COUNTY OF LOS ANGELES
DEPARTMENT OF PARKS AND RECREATION

**VESTING TENTATIVE TRACT MAP 073336 (NORTHLAKE)
PARK CONDITIONS OF MAP APPROVAL AND TRAIL COMMENTS
REGIONAL PLANNING MAP DATED FEBRUARY 17, 2015
SUBDIVISION COMMITTEE MEETING ON APRIL 2, 2015**

PARK OBLIGATION REPORT

VICINITY MAP

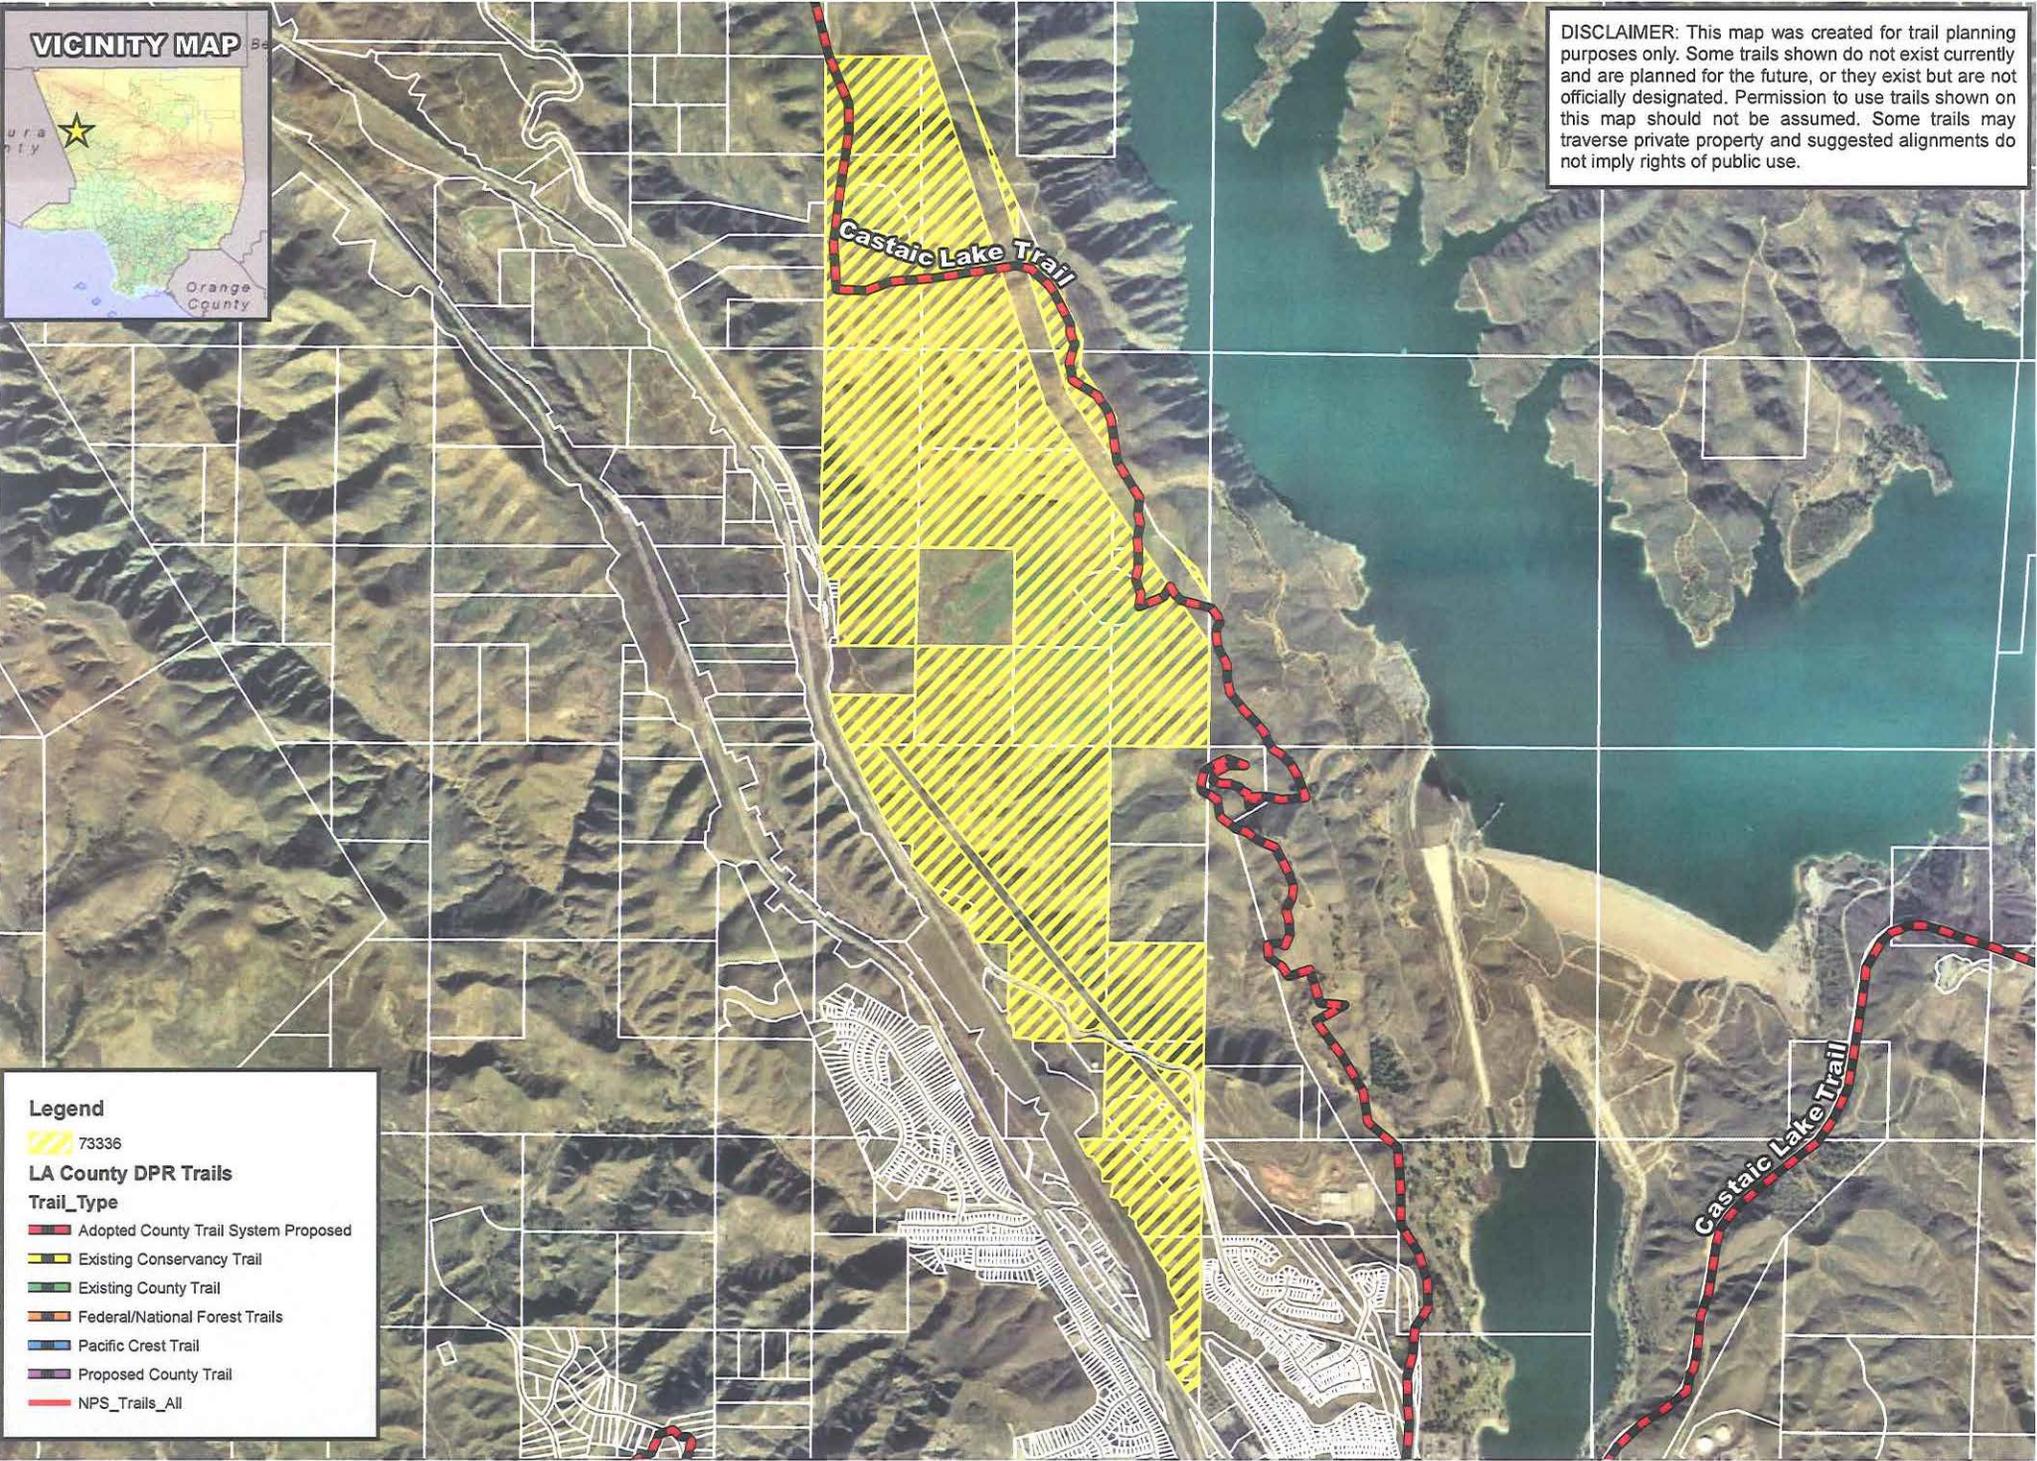
The Department is requiring the Subdivider to dedicate a twenty-foot (20') wide easement to the County for Multi-Use (hiking, mountain biking, and equestrian) trail purposes and construct a variable seven to ten-foot (7 to 10') wide natural trail #1 within the dedicated trail easement to be designated as the Castaic Lake Trail and install appropriate trail infrastructure (see attached trail map).

Map is on HOLD until details of required trail alignment, trail exhibit map, road crossings and pertinent trail section views, as specified below, are defined to the satisfaction of the Department.

1. (HOLD) Contact Robert Ettleman, Park Planner to continue coordinating Castaic Lake Trail planning efforts to appropriately revise subdivision map.
2. (HOLD) Provide a Trail Exhibit Map sheet with appropriate trail section view(s) to display the Castaic Lake Trail alignment including possible connectivity to the proposed public park site designated as lot 359, shown on map sheet #3, and #4. See attached Castaic Lake Trail map for display of adopted trail alignment.
3. (HOLD) Denote, "Twenty foot wide multiuse (hiking, mountain biking, and equestrian) trail easement to be dedicated to the County of Los Angeles," appropriately along the trail alignment within the requested trail exhibit map.
